2016/06/01

MVAA-150/180/220/260/300/460 Series
Rear Cover Exterior、Color and Screw Change Notification

3. Design Change

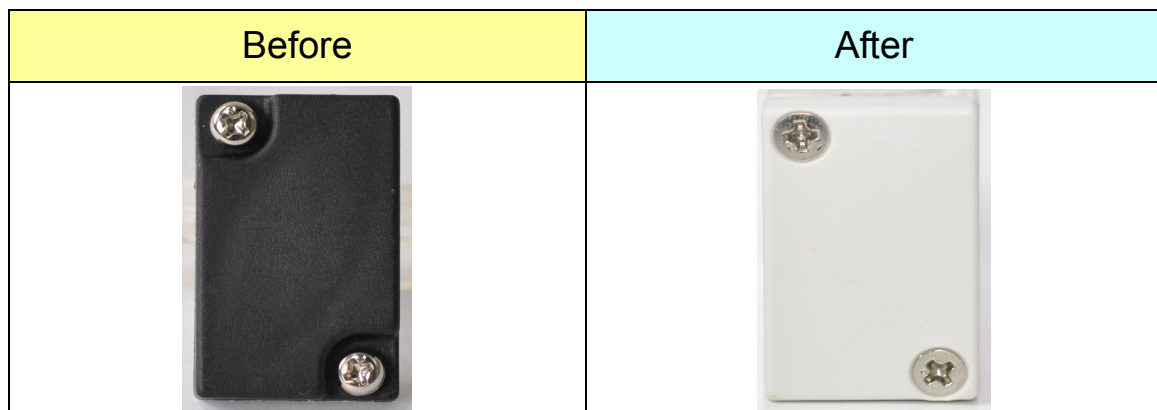
To strengthen the company identification and unify the brand image.

3.1 Rear cover screw Change :

Product	Before	After
MVAA-220-3A1	M3x0.5x8L	M3x0.5x10L
MVAA-220-4A1		
MVAA-300-3A1	M4x0.7x10L	M4x0.7x10.5L (Screw Headφ7)
MVAA-460-3A1		
MVAA-260-4A1		M4x0.7x12L (Screw Headφ7)
MVAA-300-4A1		
MVAA-460-4A1

A. MVAA-220 Series : Example: MVAA-220-4A1

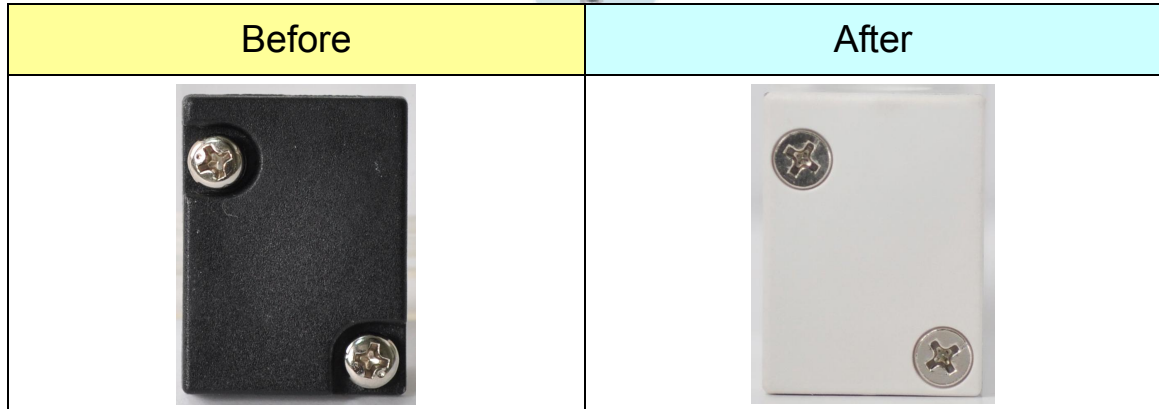
3.2 Rear cover exterior and color change :
